Overview: Production error; immobilizer wire (orange/black) in pin position #4 instead of pin position #5. Although an effort to correct the issue was made, some quantity of harnesses did get shipped before the issue was spotted. We are advising to inspect the harness BLADE connector before attempting to install the harness and program the module.

Descripción general: El nuevo arnés en T FTI-STP1 requiere modificaciones para su uso en aplicaciones de transmisión automática (AT).

FTI-STP1: Notas de instalación y configuración

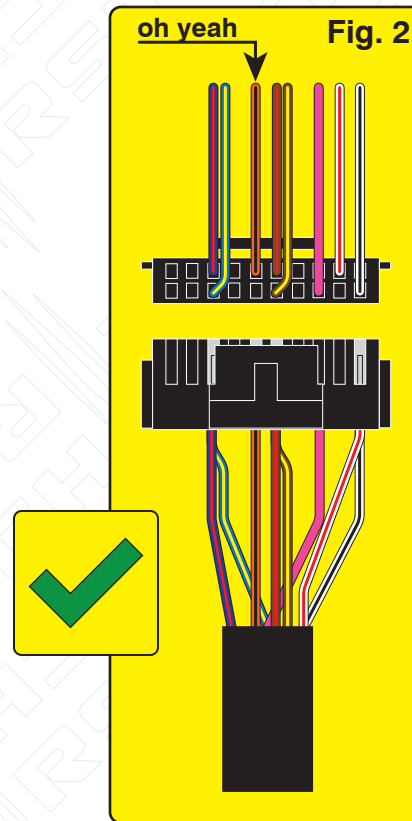
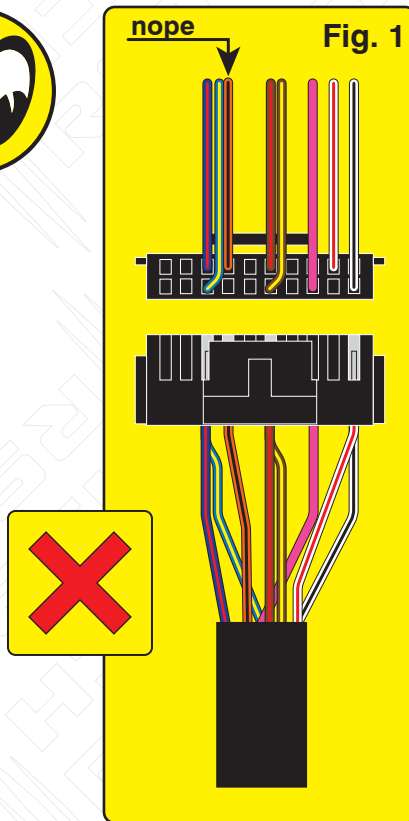
Issue: Module fails to program to vehicle, will not allow the vehicle to be remote started.

Correction: Step 1.) Locate the orange/black wire and confirm whether it is positioned as illustrated in Fig. 1 or Fig. 2. If the wire is as illustrated in Fig.1, proceed with Step 2 through 5 and complete the repair procedure outlined, if the wire is as illustrated in Fig. 2, correction is not necessary, proceed with harness installation and module programming.

Step 2.) Using a pick, lightly depress the catch that secures the terminal in the housing then remove the wire and terminal from the housing.

Step 3.) Using a fine tip razor or utility knife, insert the blade beneath the terminal catch and raise it slightly, so that it can be reused to secure the terminal when reinserted into the BLADE connector housing.

Step 4.) Refer to Fig, 2 for correct position of the orange/black wire (next to brown/red) then reinsert the terminal, pressing lightly until the catch 'snaps' into place, securing the terminal in the connector housing.

Step 5.) The repair is complete, proceed with installation and programming.

MODIFICACIÓN REQUERIDA PARA APLICACIONES DE TRANSMISIÓN AUTOMÁTICA ÚNICAMENTE

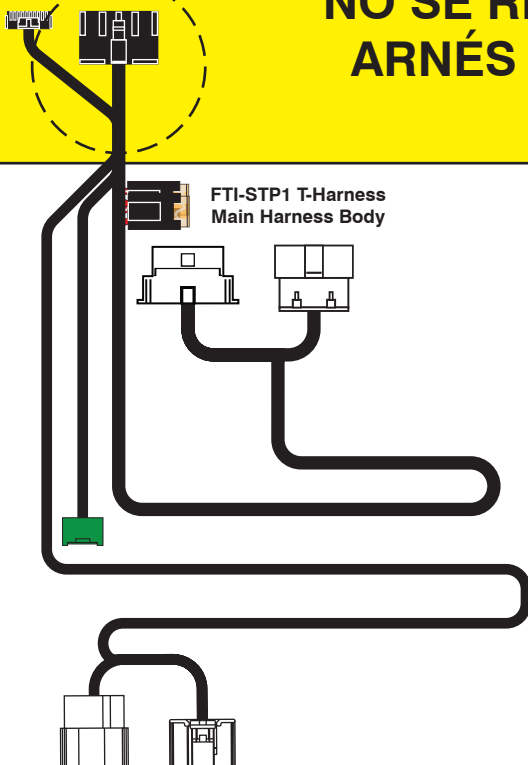
Problema: El arnés en T FTI-STP1 ha sido diseñado para ser compatible con AT (transmisión automática) y MT (transmisión manual), pero debido a una supervisión de la producción, el mecanismo de selección se estableció por defecto en el modo MT.

El uso de un arnés configurado para una aplicación MT, en un vehículo equipado con AT, podría provocar daños en el módulo del vehículo. Se recomienda que el arnés vuelva al modo AT antes de instalarlo en vehículos equipados con transmisión automática.

Corrección: Localice el cable rojo/negro (+ embrague) provisto en el conector CN1 del conjunto del arnés principal. Corte el cable rojo / negro, ya sea al ras del conector CN1 o dejando suficiente cable expuesto para que pueda aislar y asegure los extremos del alambre que quedan después del corte. Aísle cada uno de los extremos restantes del cable rojo/negro y asegúrelos para evitar cualquier posibilidad de cortocircuito.
